Reviewer #1

The paper presents a new analytical model accounting for the vertical variations in horizontal wind speed to assess wind turbine power production. The approach relies on the Taylor expansion of wind profile measurements in the rotor swept area obtained from Doppler lidar observations. Results from the analytical model are validated against OpenFAST simulations and measurements from wind turbines operating in the Gotthard Pass wind farm in the Swiss Alps. The topic of the manuscript is of interest since this method provides an estimate of turbine power production at a relatively low computational cost compared with other approaches. Moreover, the detailed knowledge of the turbine mechanical characteristics is not required, and the wake effects between turbines can be addressed by this new method. However, the manuscript lacks clarity, organisation, and rigour, which hinder its readability and reproducibility. More work is needed to improve the manuscript by addressing the following comments:

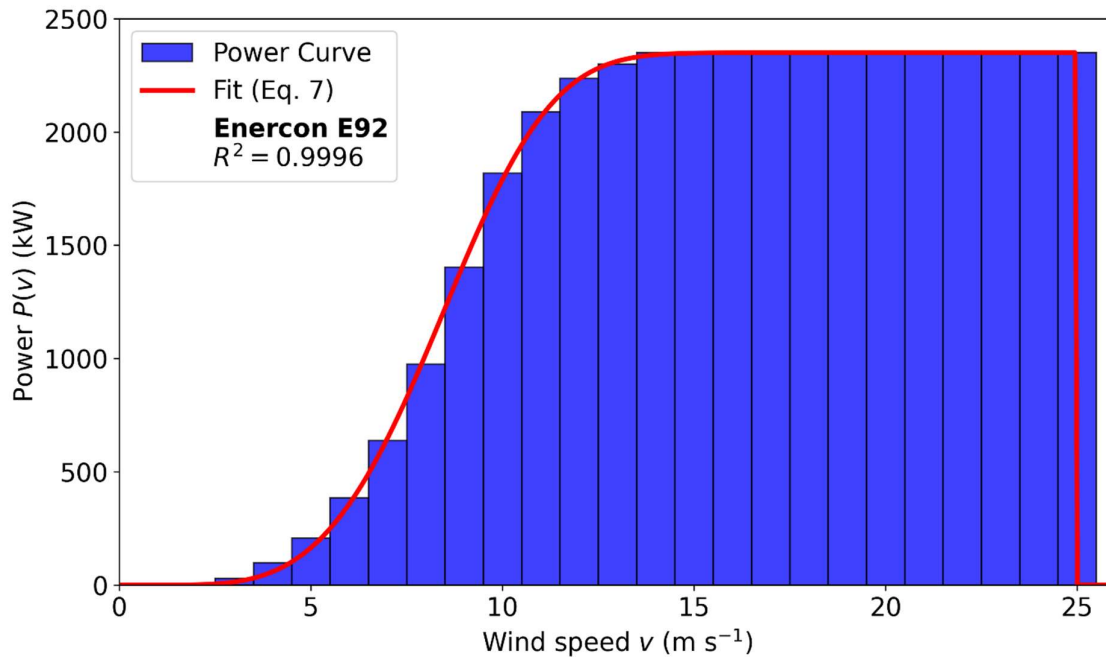
Page 8: Equation 7, I think a figure comparing the data-based, or binned power curve against the functional approximation would be helpful to see. Does the equation have a range of wind speeds for which it is valid or does it work cut-in to cut-out?

Thank you for this useful suggestion. We realize that we have not mentioned the complete piecewise definition of this equation, and changed that accordingly. This now includes that $P = 0$ for $v < v_{in}$ and $v > v_{out}$. We have also included a new figure including the Enercon E92 binned power curve and the subsequent fit of our function which shows the goodness of fit ($R^2 = 0.9996$), as well as the fit parameters used in for this wind turbine. This is now Figure 2 in the manuscript.

We copy the figure here for your convenience:

Figure 8. Spatial progression of wind direction over the Gotthard wind park, illustrated by wind roses...

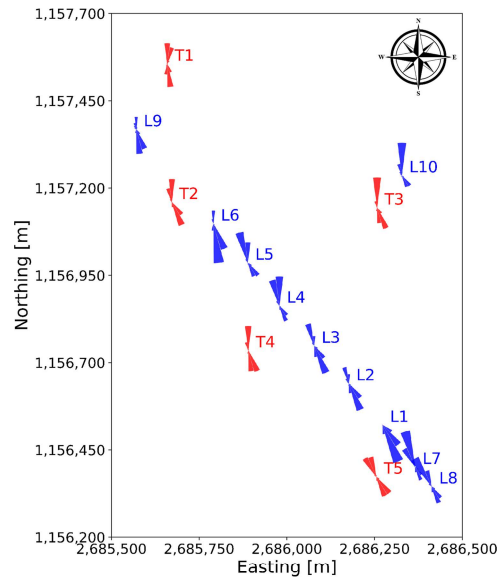
Page 8: "it naturally enables the removal of anomalous or clearly unphysical measurements before constructing the analytical profile", a more standard approach might be to only include data from wind sectors where the turbine is not waked right?

This is true, however the nature of the Gotthard wind park does not allow us to do that. While we don't show this detailed overview of the winds in this manuscript, we do cite our previous dataset paper (<https://open-research-europe.ec.europa.eu/articles/5-9>), where in Figure 8 (copied here for your convenience), one can see that the winds are strongly channeled along the pass. It is for this reason that we split the winds in "Northerly" and "Southerly".

To answer your question in the manuscript concretely, we will rephrase as follows:

"Another useful feature of the Taylor-expanded wind profile is that it naturally enables the removal of anomalous or clearly unphysical measurements before constructing the analytical profile. This enables wake filtering even when data from adjacent, wake-free wind sectors are not available, as is often the case in strongly channelled flow environments such as the Gotthard wind park."
